To: Energy Facility Siting Council

From: Christopher M. Clark, Senior Siting Analyst

Date: March 6, 2026

Subject: Agenda Item G (Potential Action Item):
Biglow Canyon Wind Farm, Request for Amendment 4 – Review of Draft Final Order and Possible Final Decision for the March 19-20, 2026, EFSC Meeting

Figure 1. Original and Revised Collector Substation Location and Transmission Corridor

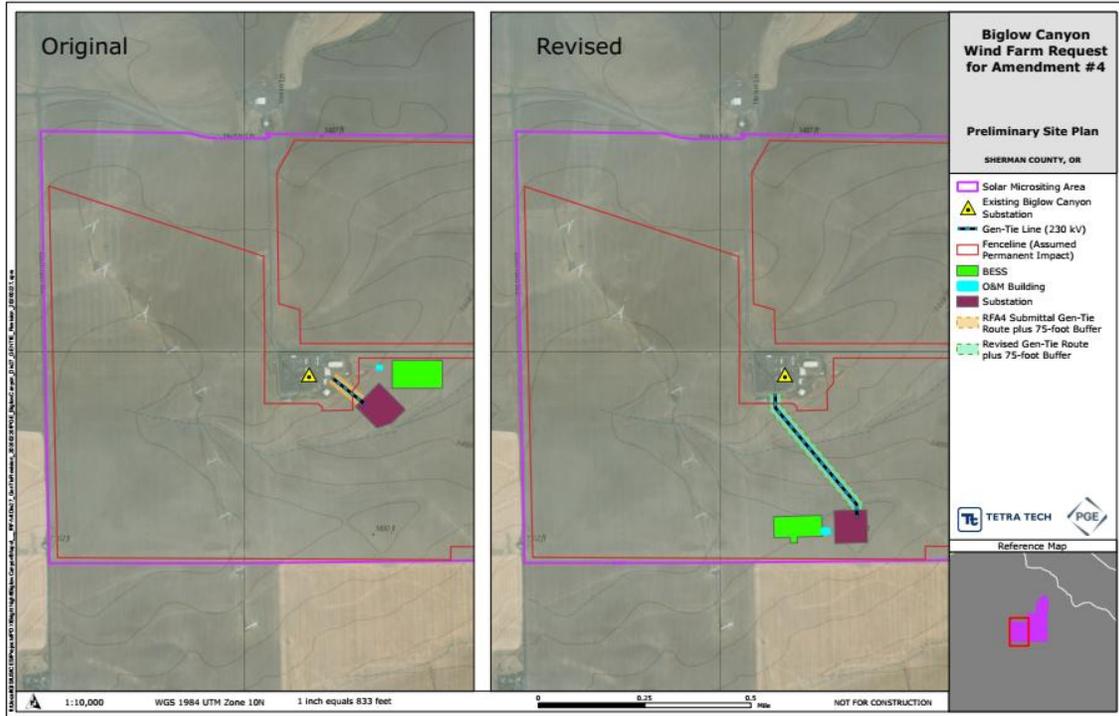
In its comments on the Proposed Order, the certificate holder requested changes to recommended Amended Condition 119 to provide additional flexibility in transmission line siting. Specifically, the certificate holder requested permission to defer identification of the final location of the substation and transmission corridor to the final site design.

In response to this issue, the Department noted that under OAR 345-025-0010(5), the Council must specify an approved corridor for any transmission line approved in a site certificate. The Department noted that the certificate holder only included one proposed corridor for the 600-foot segment of 230 kV transmission line, which was presented in RFA4 Figure 2.2. The Department requested that any alternate corridors be presented so that they can be evaluated for compliance with applicable laws, rules and standards.

In its reply, the certificate holder explained that continued engineering evaluation of site conditions and infrastructure layout identified that the original substation site presented constraints relative to the existing infrastructure. Accordingly, a new location for the proposed substation and battery energy storage system (BESS) was identified to avoid low elevation areas, better align with existing infrastructure, and improve constructability, long-term operability, and overall infrastructure resilience. The certificate holder asserts that this refinement reflects prudent final engineering and results in improved consistency, new and existing infrastructure, rather than a change in project scope. Moving the collector substation location results in a corresponding adjustment to the transmission line corridor, with an updated alignment of a 230-kV transmission line approximately 1,900 feet in length, supported by three 80-foot tall steel monopole structures. The figure below shows the new location of the project substation and gen-tie transmission line, all still located within the Solar Micrositing Area.

The newly proposed substation location is within the proposed Solar Micrositing Area, and has been fully surveyed and evaluated for all applicable resources and impacts. In addition, there do not appear to be any residences or linear structures that could be inadvertently energized within the refined corridor. Accordingly, the Department recommends the Proposed Order and draft Amended Site Certificate be amended with the revised substation location. Site certificate conditions will require an updated site plan, acoustic modeling, retirement estimate, and other resource studies to be provided prior to construction.
